**KNOXVILLE/KNOX COUNTY METROPOLITAN PLANNING COMMISSION
 SUBDIVISION REPORT - CONCEPT/USE ON REVIEW**

▶ **FILE #:** 3-SA-11-C **AGENDA ITEM #** 14
 3-D-11-UR **AGENDA DATE:** 3/10/2011

▶ **SUBDIVISION:** CAMPBELL CREEK SUBDIVISION, UNIT III
 ▶ **APPLICANT/DEVELOPER:** S & E PROPERTIES
 OWNER(S): S & E Properties

C1.01

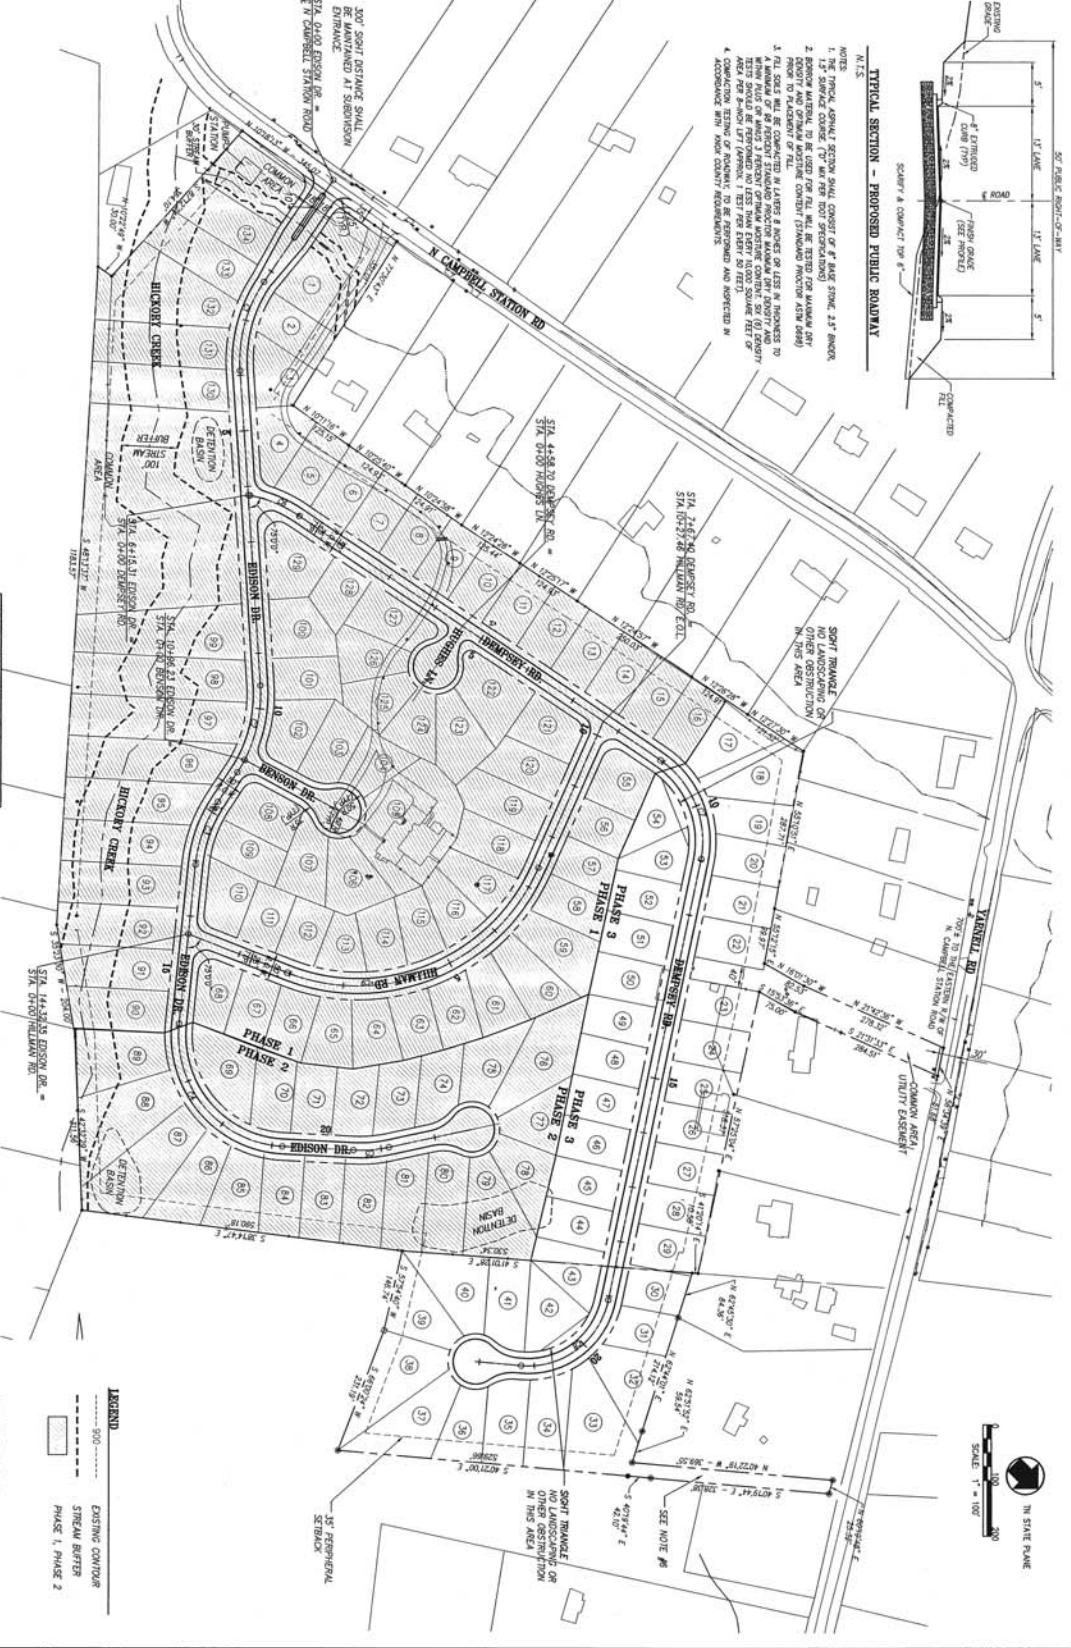
▶ **NUMBER OF LOTS:** 38
 SURVEYOR/ENGINEER: Cannon & Cannon, Inc.
 ACCESSIBILITY: Access is via N. Campbell Station Rd., a minor arterial street with a 20' pavement width within a 50' right-of-way.
 ▶ **SUBDIVISION VARIANCES REQUIRED:**
 1. Horizontal curve variance on Dempsey Rd at STA 8+92.86, from 250' to 175'.
 2. Horizontal curve variance on Dempsey Rd. at STA 19+07.36, from 250' to 150'.

2. Meeting all applicable requirements of the Knox County Department of Engineering and Public Works.
3. Placing a note on the final plat that all lots will have access only to the internal street system.
4. Including a line of sight easement across Lot 42 in order to provide the needed sight distance for the curve in Dempsey Rd.
5. Including a line of sight easement across Lots 53 and 54 in order to provide the needed sight distance for the curve in Dempsey Rd.

▶ **APPROVE** variances 1 & 2 because the existing site conditions and site's topography restrict compliance with the Subdivision Regulations, and the proposed variances will not create a traffic hazard.
